REQUEST FOR INFORMATION	DATE: February 27, 2017	NO.: RFI-464
--------------------------------	--------------------------------	---------------------

Project Name:	15051-Webster University Interdisciplinary Science Building	Project No.: 15051
---------------	---	--------------------

Subject: Linear Slot Diffusers in Lecture Hall Ceiling

9 WOOD GRILLE CEILING DETAIL
3" = 1'-0"

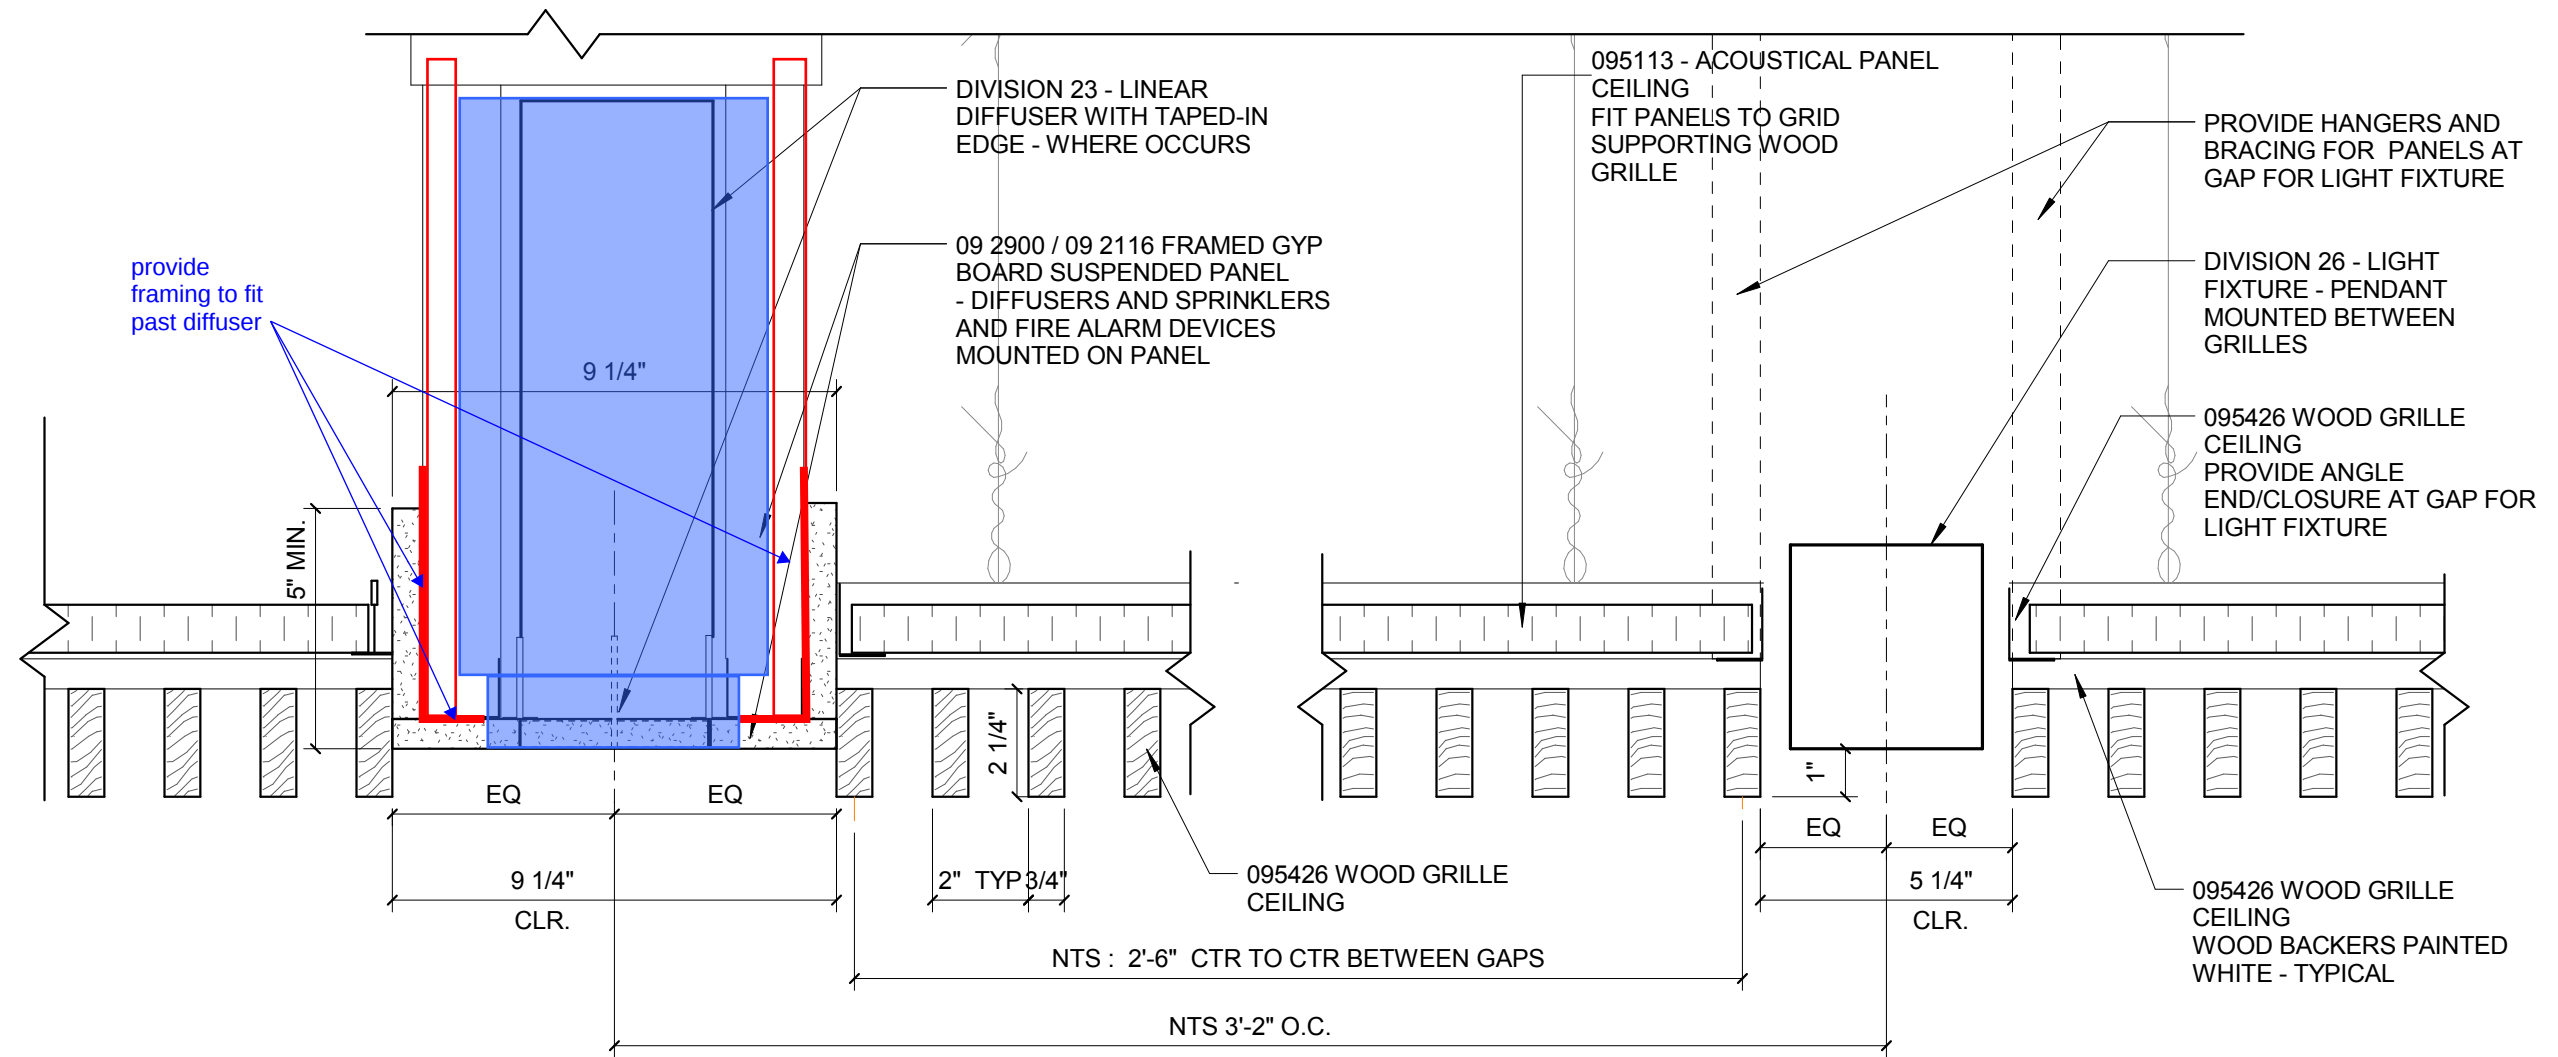
Based on detail 11 in A0841 in the Lecture Hall, there is a 4" opening for the BOD linear slot diffusers to be installed. The BOD linear slot diffuser plus plaster frame for drywall mount, will need an opening size of 6" to install. Can the ceiling detail be made to accommodate the needs of the slot diffuser?

Suggestion: Changing the ceiling detail will allow for install of the specified linear slot diffusers.
Impact: If the detail cannot change, diffusers will need to be resized and reordered at additional cost and schedule impact of 3-4 week standard lead time after selection and approval.

Provide framing to fit around diffusers. Maintain 9 1/4" overall dimension for gyp board. Attached is suggestion
